**SECTION 96(2)  
APPLICATION TO  
DA/251/2013**

**20 PACIFIC HIGHWAY,  
BENNETTS GREEN**

Figure 4 – Approved and Proposed layout of Lot 2 Bulky Goods building, service and parking areas

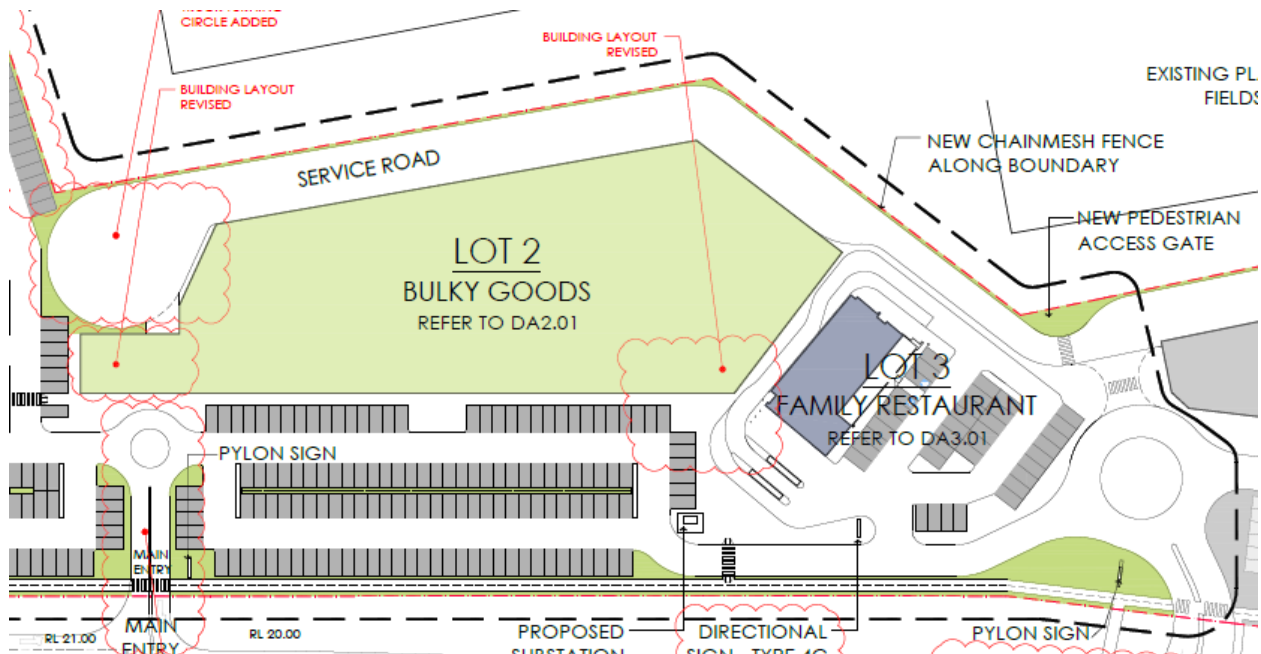
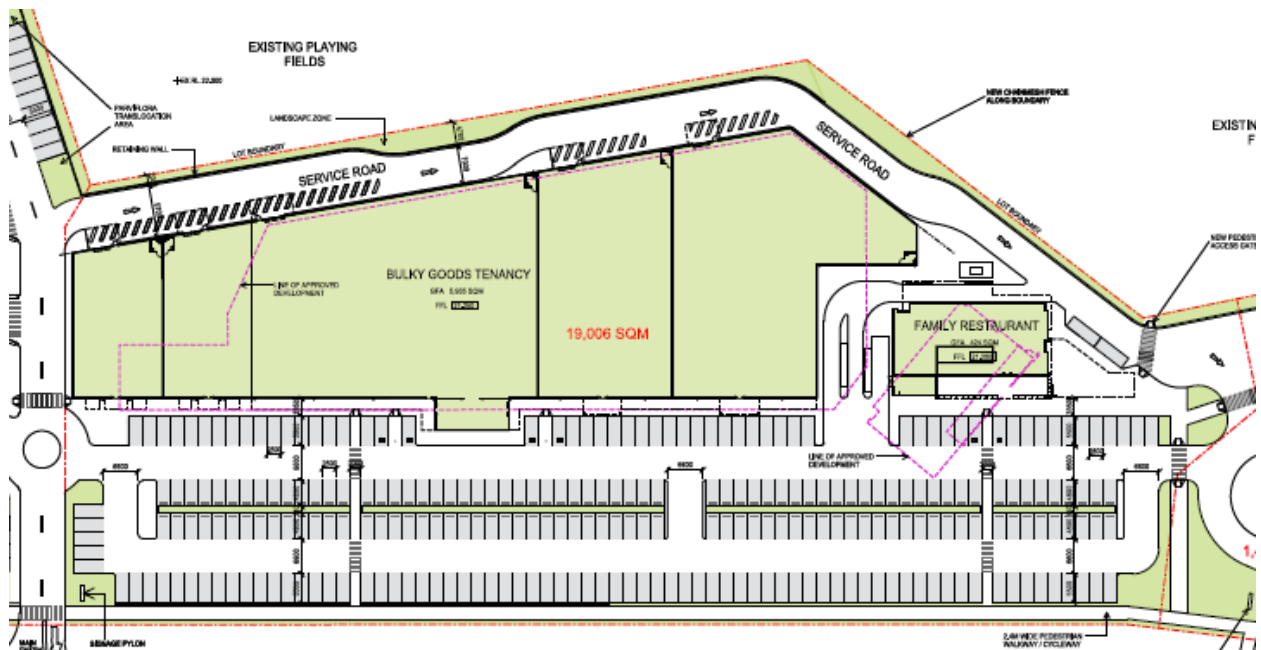
The proposed reconfiguration of the Lot 2 Bulky Goods tenancy building is illustrated in Figure 4 below.

Due to the removal of the service vehicle turning head on Lot 2, the built form of the Lot 2 bulky goods building has been reconfigured. The building has generally retained the setback from the western boundary to the adjoining sports field, however due to the redesign of the service area and the single direction of service vehicles through this area, larger landscape areas have been accommodated.

While the bulk and scale of the building remains generally consistent with the approved design for Lot 2, the increased landscape areas provide scope for an improved landscape response to the western adjoining open space, which is discussed in detail below in Section 8.1.2.

Figure 5 – Approved and Proposed configuration of restaurant

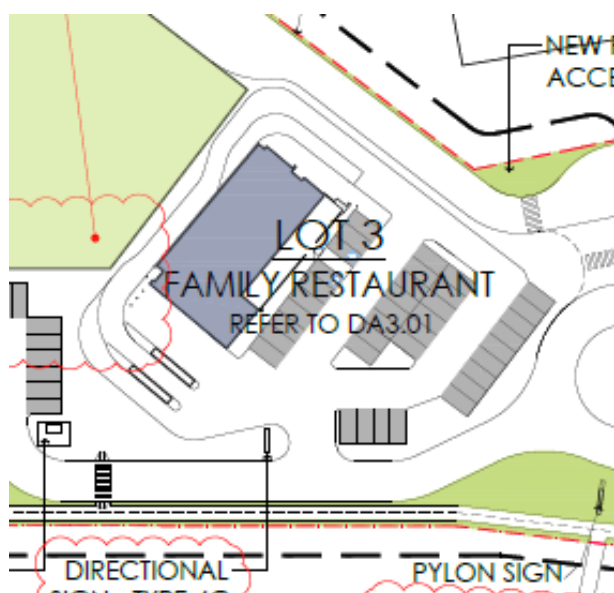
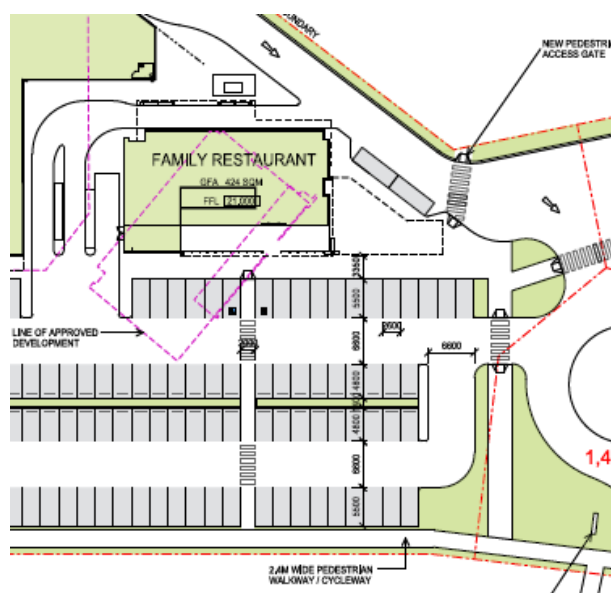
The proposed amendments to the approved Family Restaurant are illustrated in Figure 5 below.

The family restaurant remains consistent with the approved development with the orientation amended in response to the changes proposed to the adjacent bulky goods tenancies on Lot 2. The floorspace of the restaurant is not proposed to change, however will be reorientated to face the Pacific Highway frontage. The parking and access has been modified to respond to the reorientation of the restaurant building and increase efficiency of the layout in relation to circulation and access.

The reconfiguration retains the vehicle circulation around the restaurant for service vehicles and customer 'drive-through'.

Figure 6 – Approved and proposed modification to Lot 3 tenancy (subject to Stage 2 application)

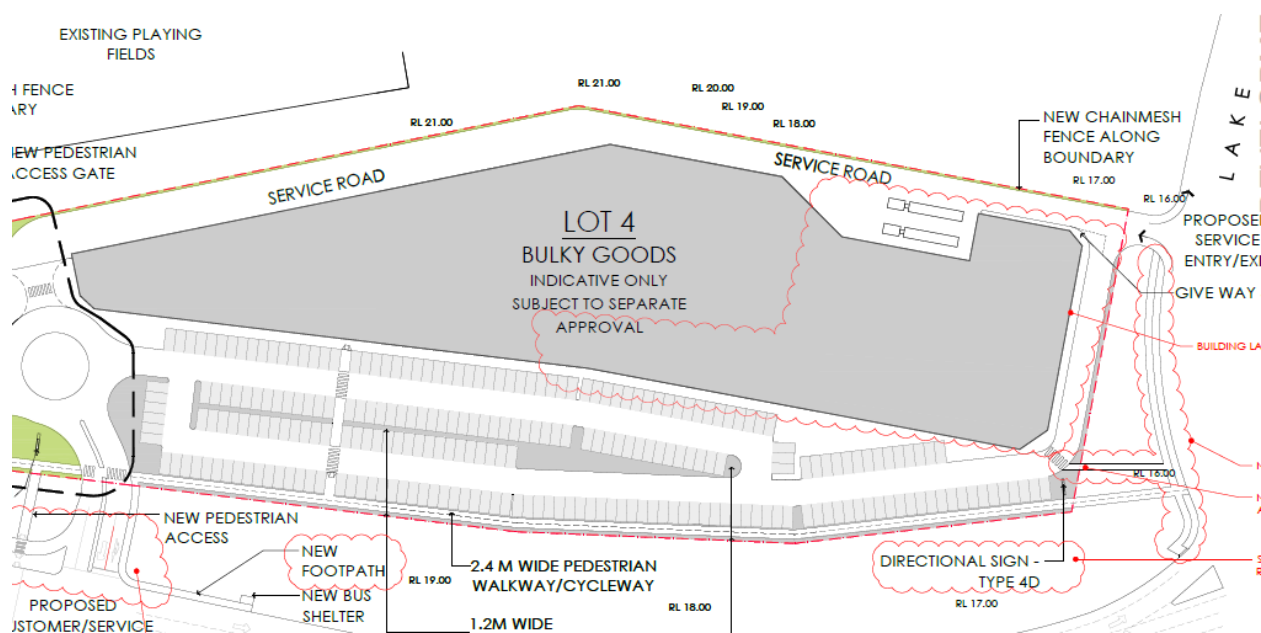
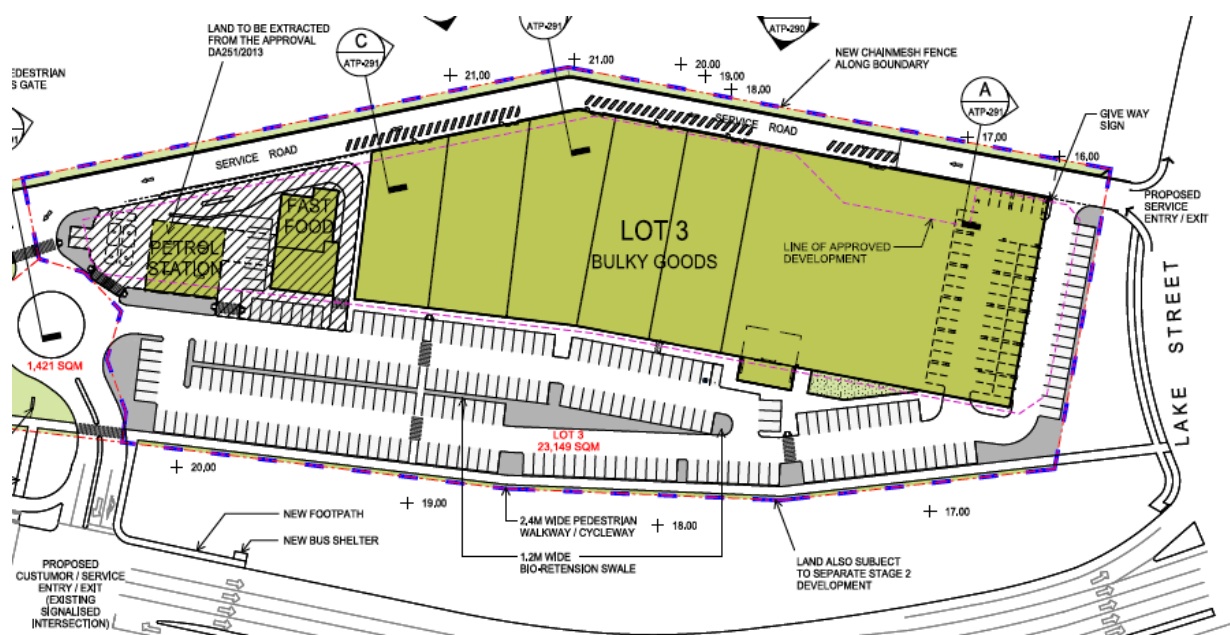
This modification proposes to reconfigure the approved building envelope, as illustrated in Figure 6 below. It is noted that the final built form detail will be the subject of the Stage 2 Development Application.

The revised building envelope provides for 8,771sqm of floorspace, which is a reduction of approximately 1,900sqm from the approved building envelope. Building envelope has been shortened to accommodate an additional building site, which will be subject to a separate application.

The revised built form proposes a more consistent building setback from the western site boundary adjoining the open space, however the overall setback from this boundary remains generally unchanged.

Figure 10 – Augmented section where *Grevillea parviflora subsp. parviflora* is proposed to be translocated

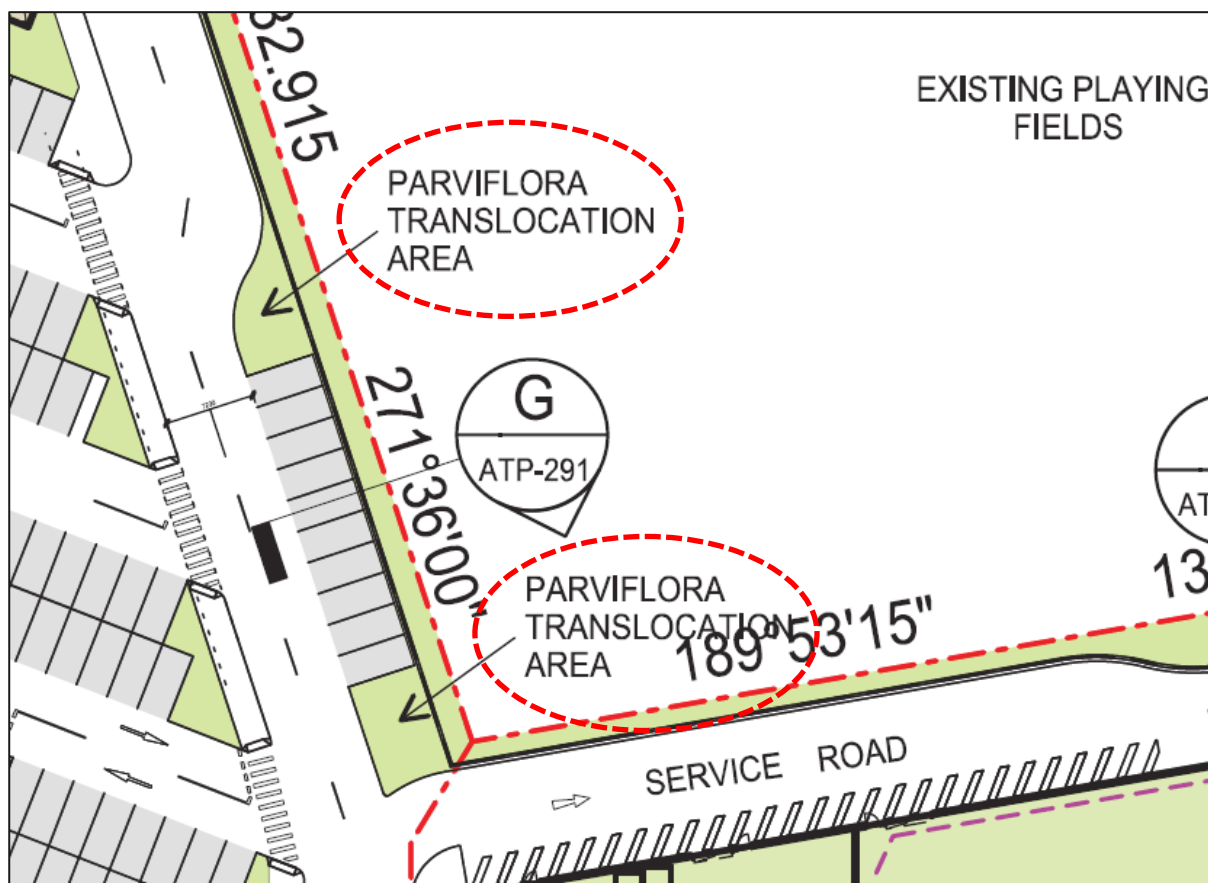
The proposed modifications have necessitated the amendment of the area where the translocation of *Grevillea parviflora subsp. parviflora* has been undertaken. The applicant is committed to ensure that compliance with the conditions of consent are met and that 10 individuals of *Grevillea parviflora subsp. parviflora* to be translocated within the site boundary.

Accordingly, it is proposed to translocate an additional nine individuals into a new translocation area. The 10 individuals will therefore be accommodated across two separate areas as shown in the Figure 10.

Figure 12 – Location of acoustic wall

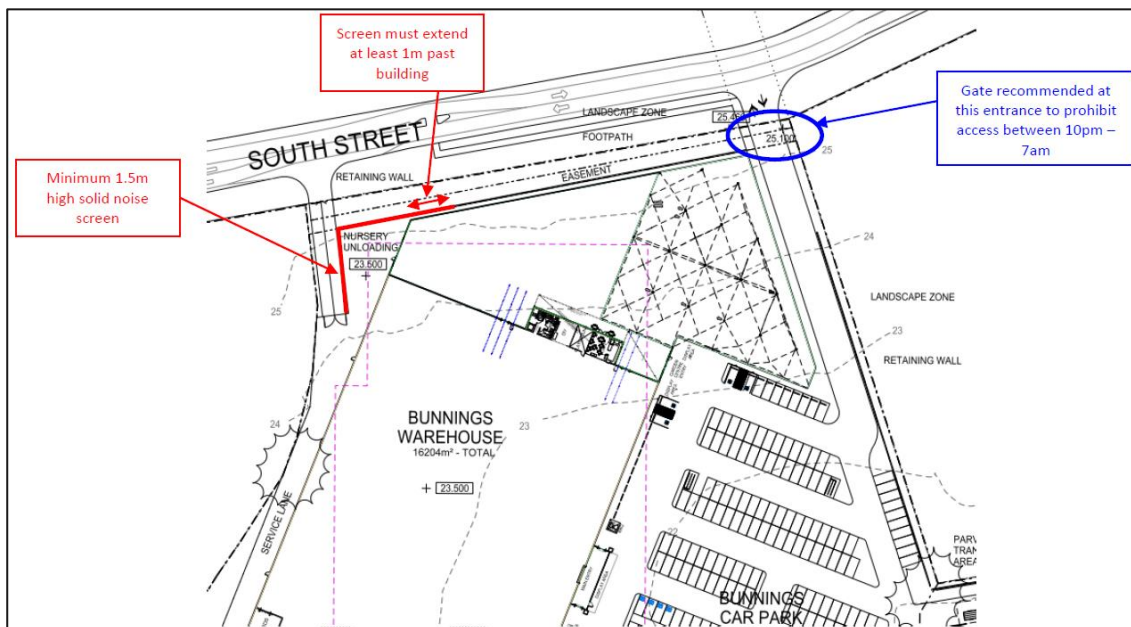
- A noise screen is recommended along the South Street Service vehicle entrance as illustrated below. Screen must be of a solid impermeate construct (FC sheet, lapped and capped timber, masonry etc.) and at least 1.5m high.
